June 29, 2020

RE: Permit Application for the Greenpointe Class
Two Construction, Demolition, and Land-
Clearing Debris (C&D) Landfill Expansion
Permit No.: LF2-00001
Project No.: 16227-0004

In response to your comments via email on June 8, 2020 for the referenced project, we have the following comment response. The following items were brought to our attention in the aforementioned email and are listed along with our response to each item:

FILE NAME:	E16227-PLANS	SHEET C-51
REFERENCE FILE:	E16227-BASE	
PROJECT NO.:	16227-0004	
DWG NO.:	01,1168-D21

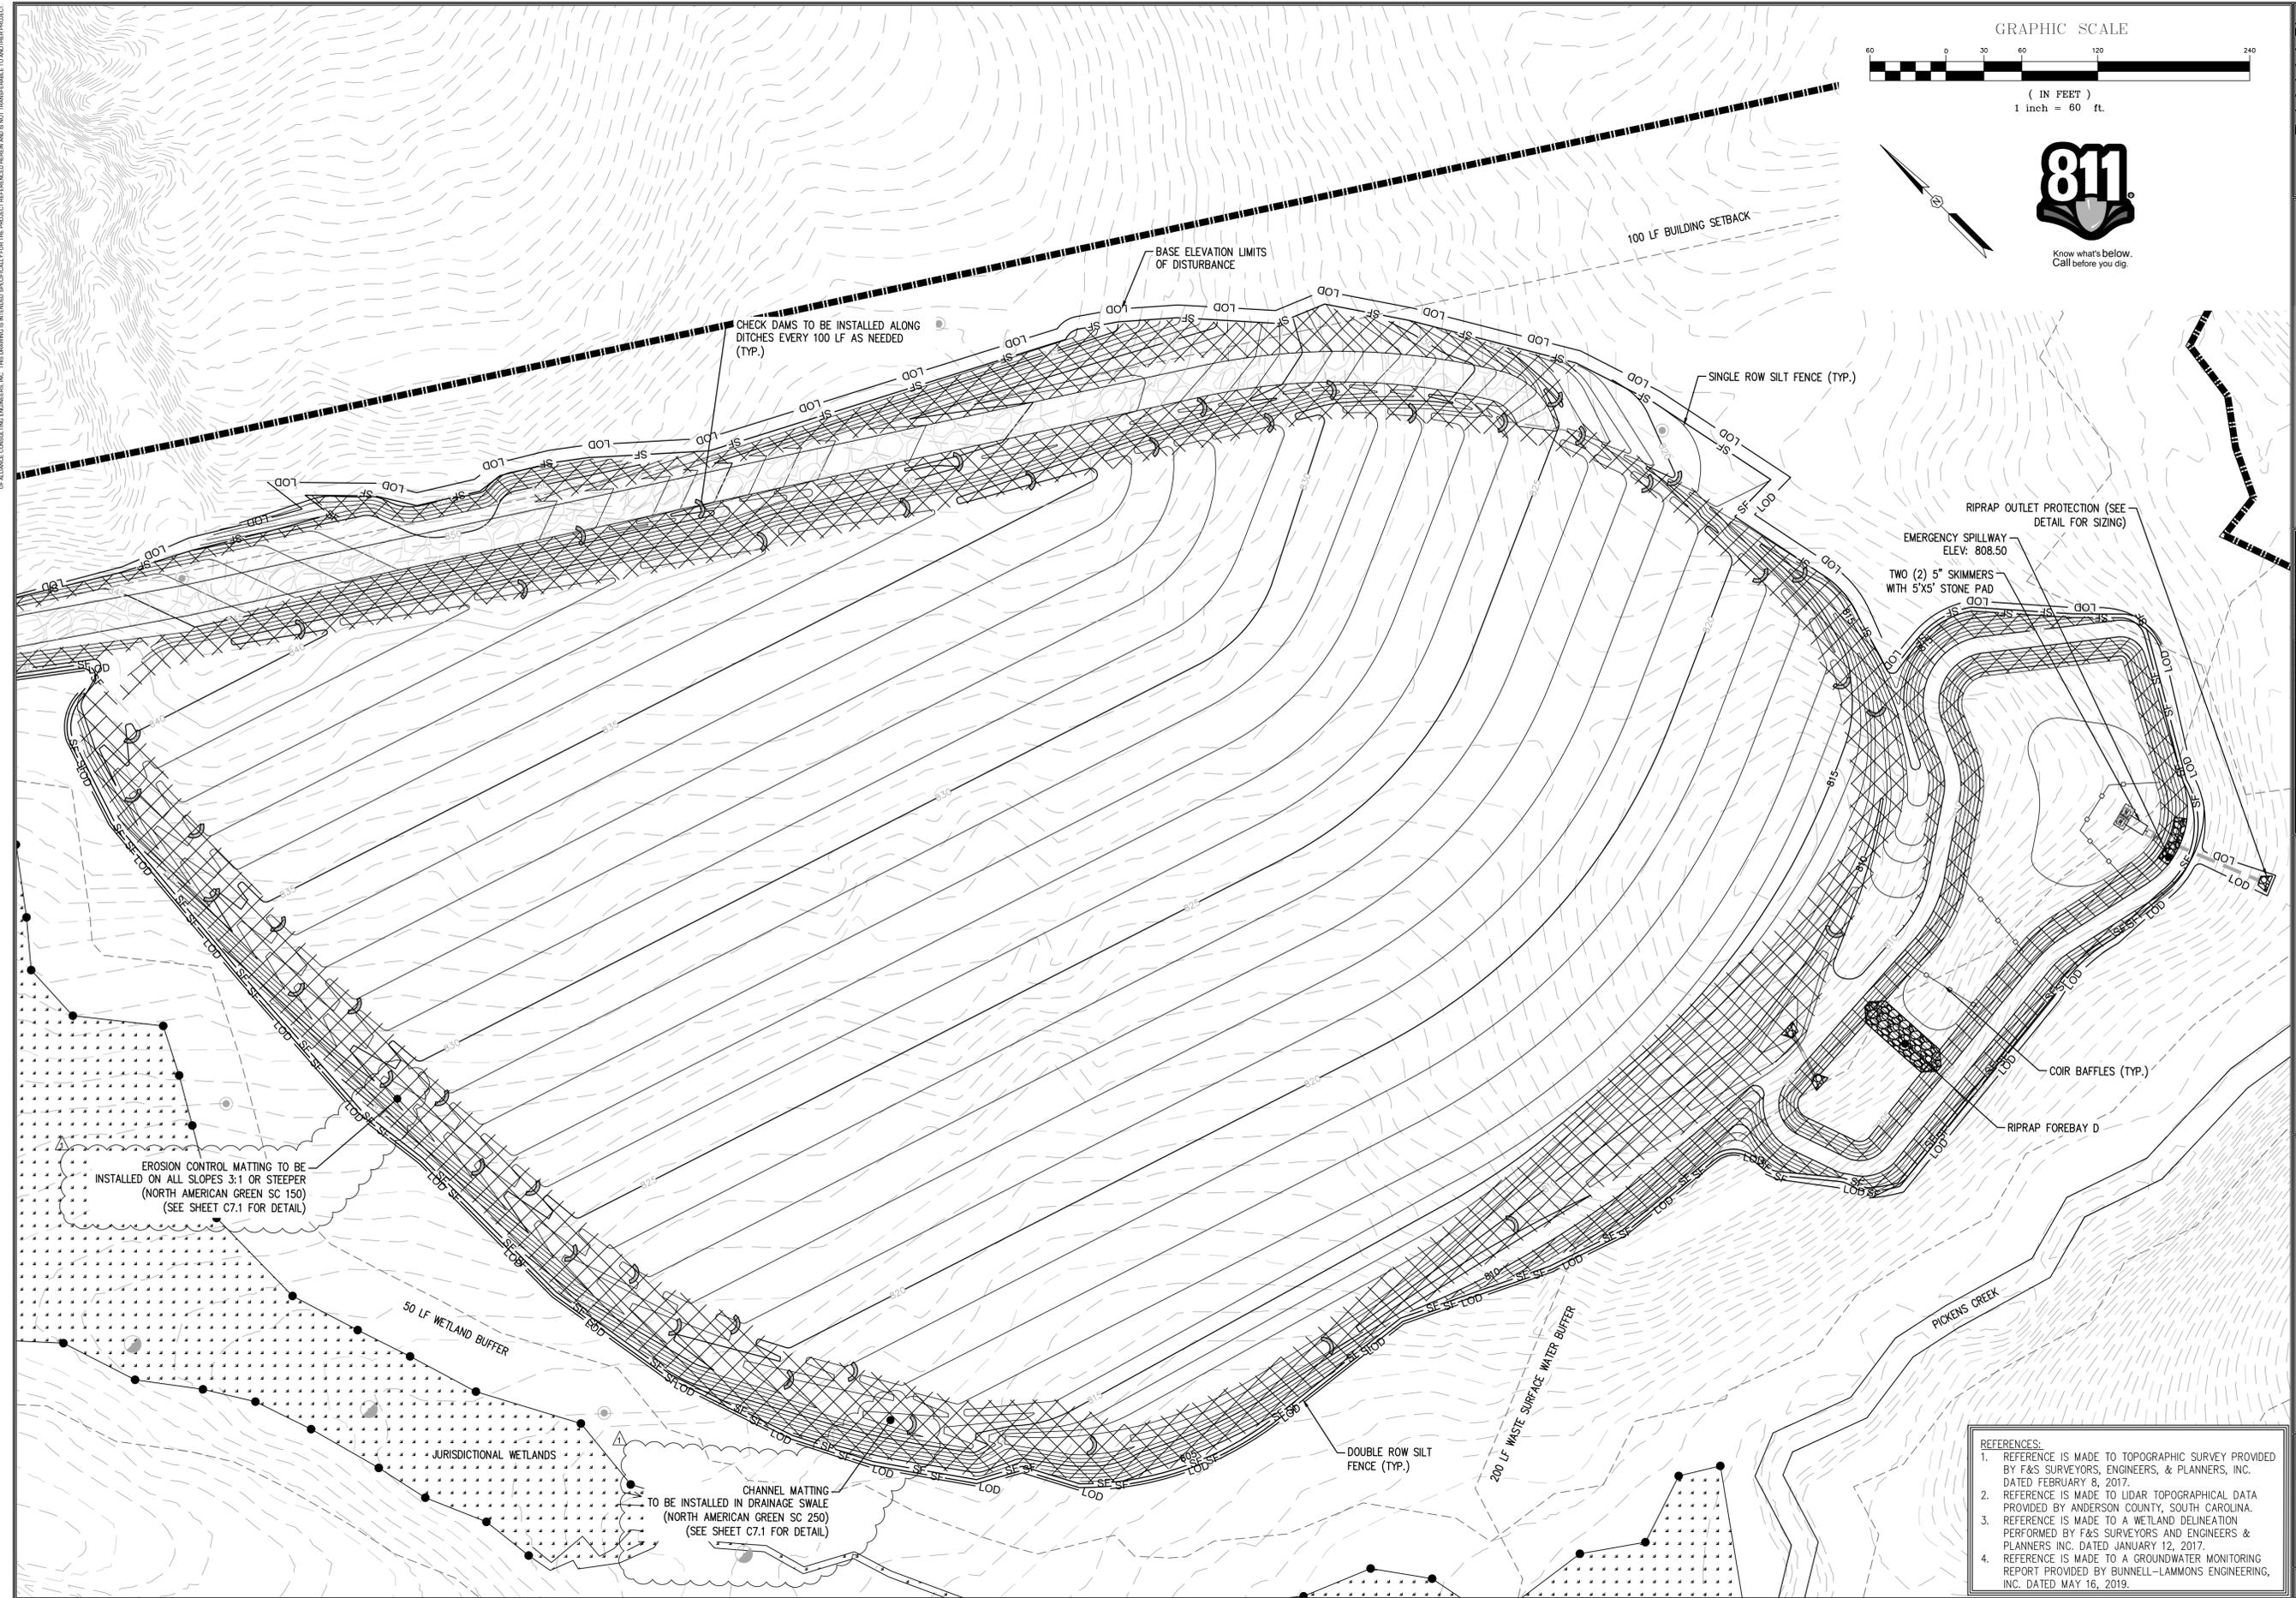
15. *Please move back the 1st row of Coir Baffles back a little on drawing sheet C5.1 so it is not so close to the rock forebay;*
 - **Silt baffles have been revised accordingly on Sheet C-5.1 of the Construction Plans (Drawing No. 01,168-D21 dated June 26, 2020).**

FILE NAME:	E16227-PLANS	SHEET C-5.2
REFERENCE FILE:	E16227-BASE	
PROJECT NO.	16227-0004	
DWG NO.	01,1168-D21

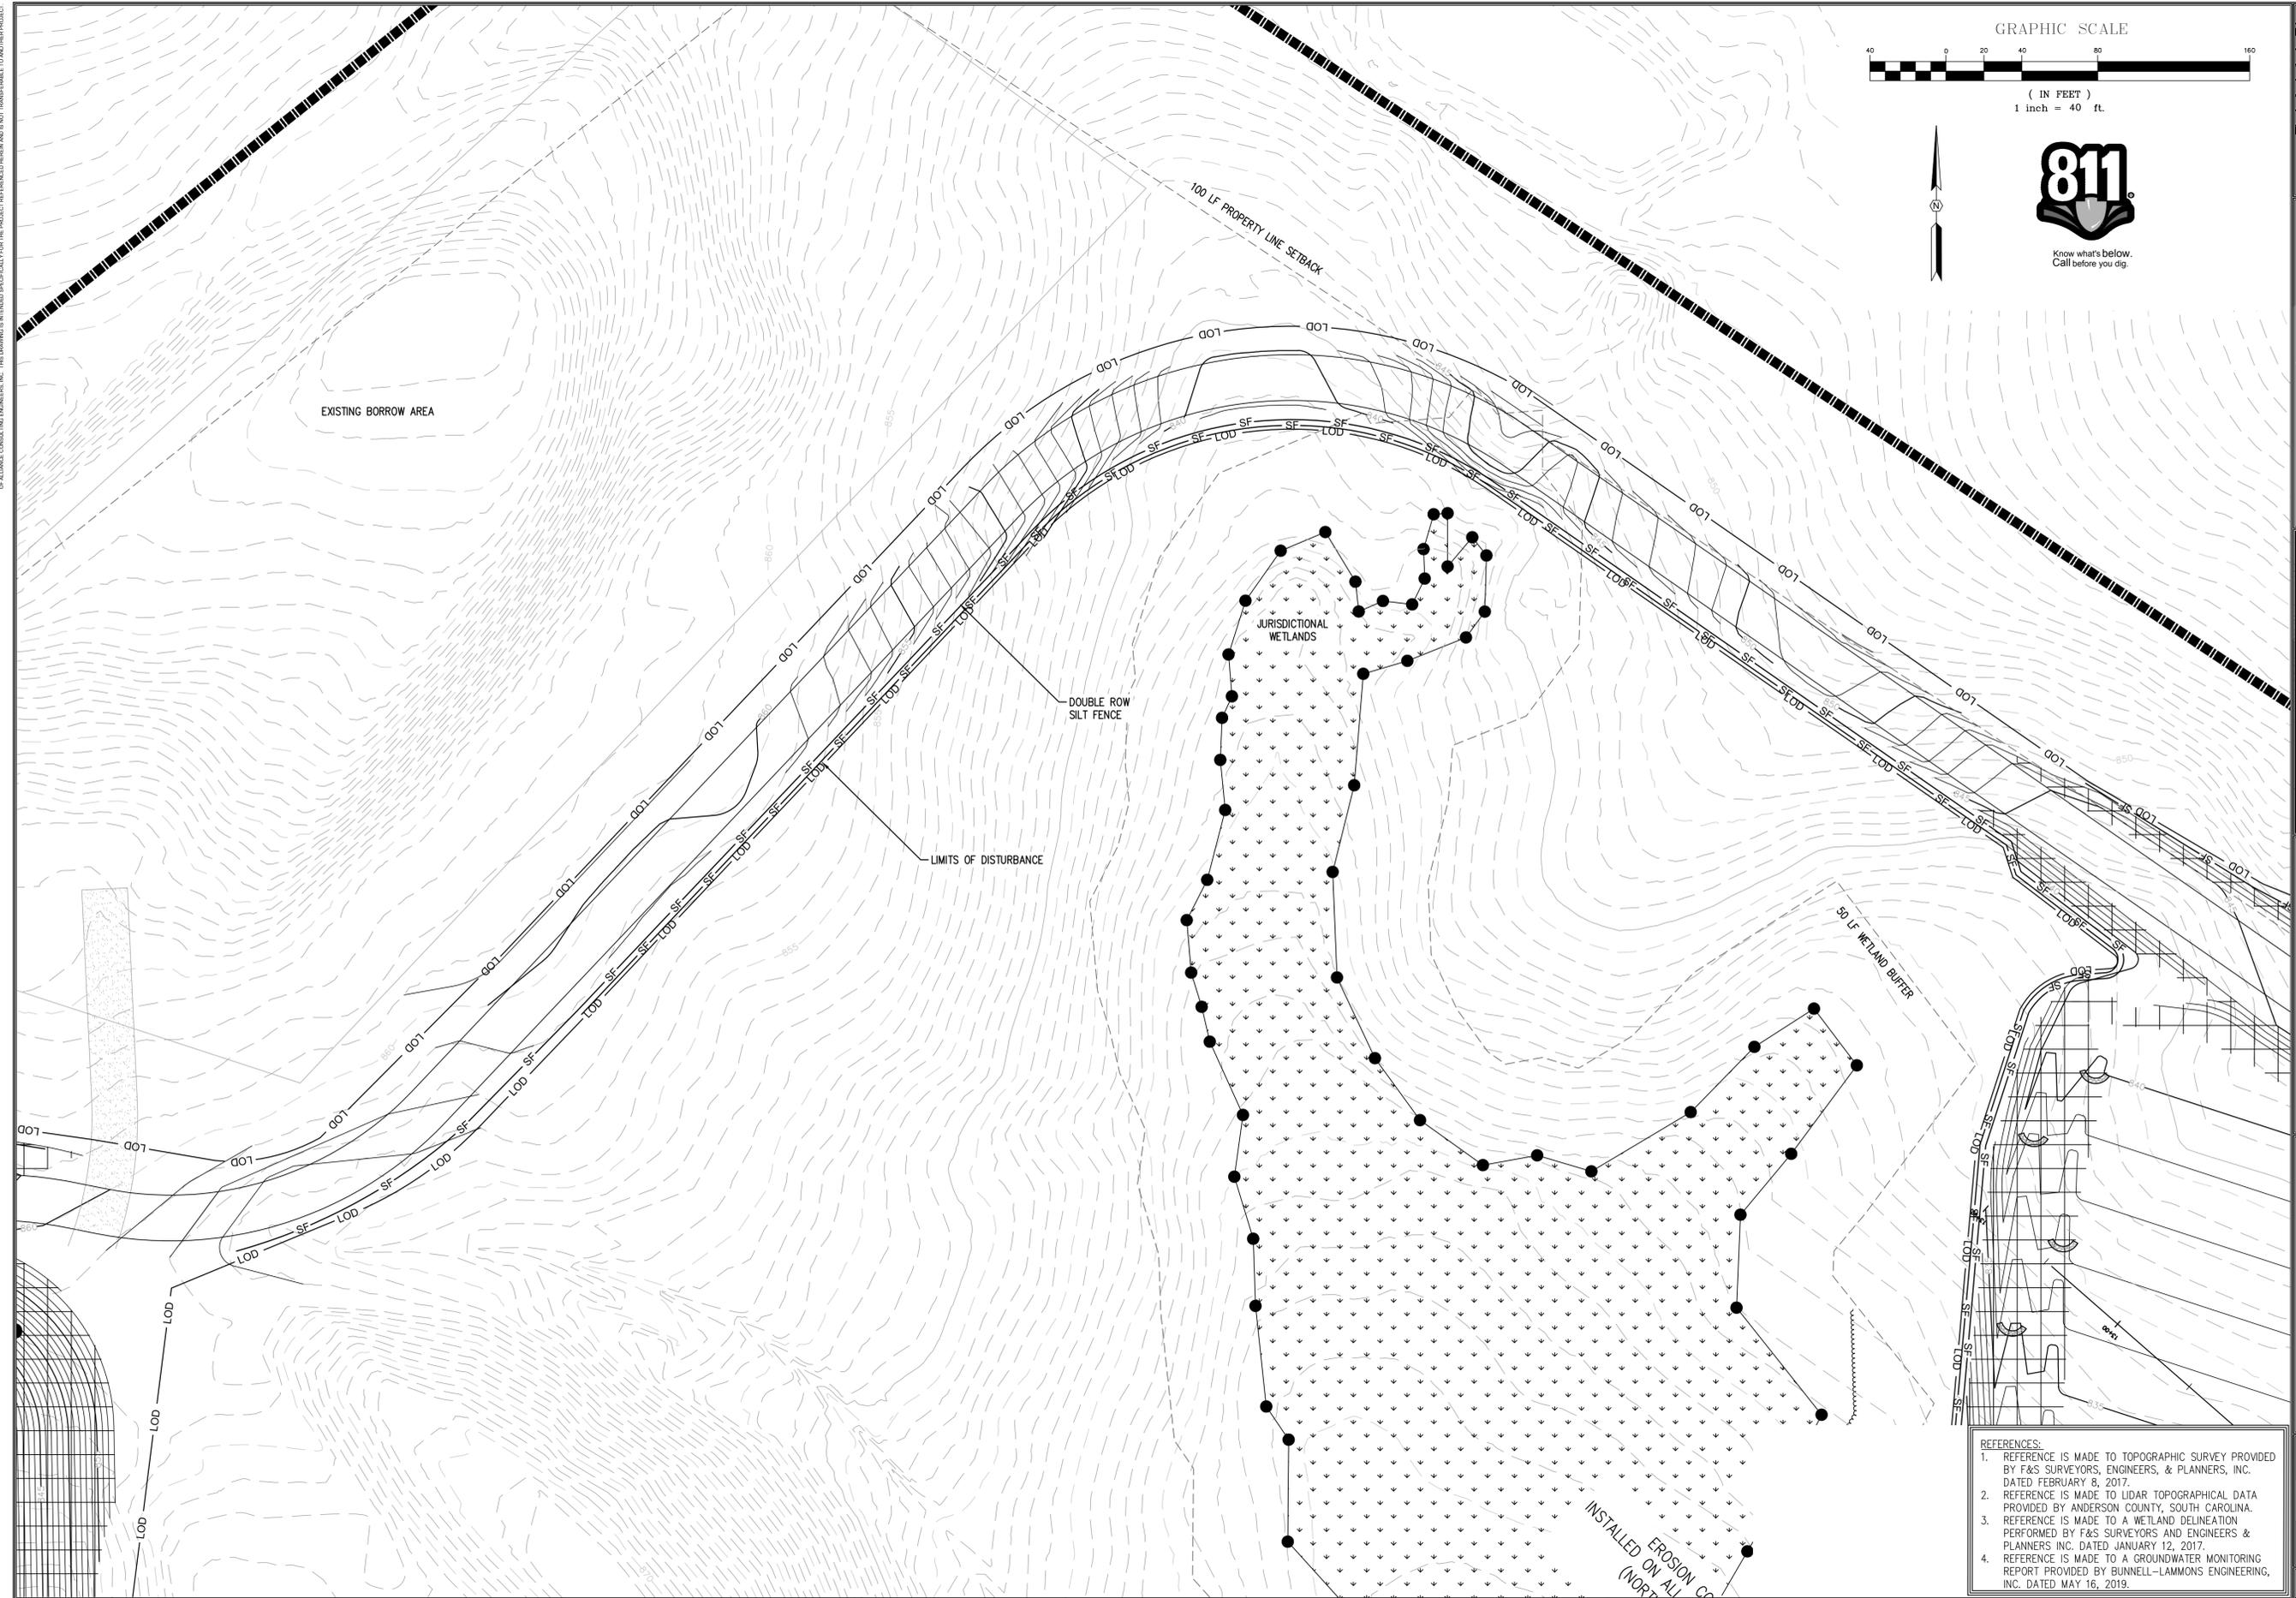
18. Please clarify on drawing sheet C5.2 the buffer width is reduced by the access road, a surface water protection plan will need to be developed and Compliance option 2 from the CGP will need to be addressed in the SWPPP;

- **The C-SWPPP has been revised to state that Compliance Option B from the Construction General Permit (CGP) will be utilized and the Surface Water Protection Plan Construction Sequence has been added to Section 1.7 of the C-SWPPP.**
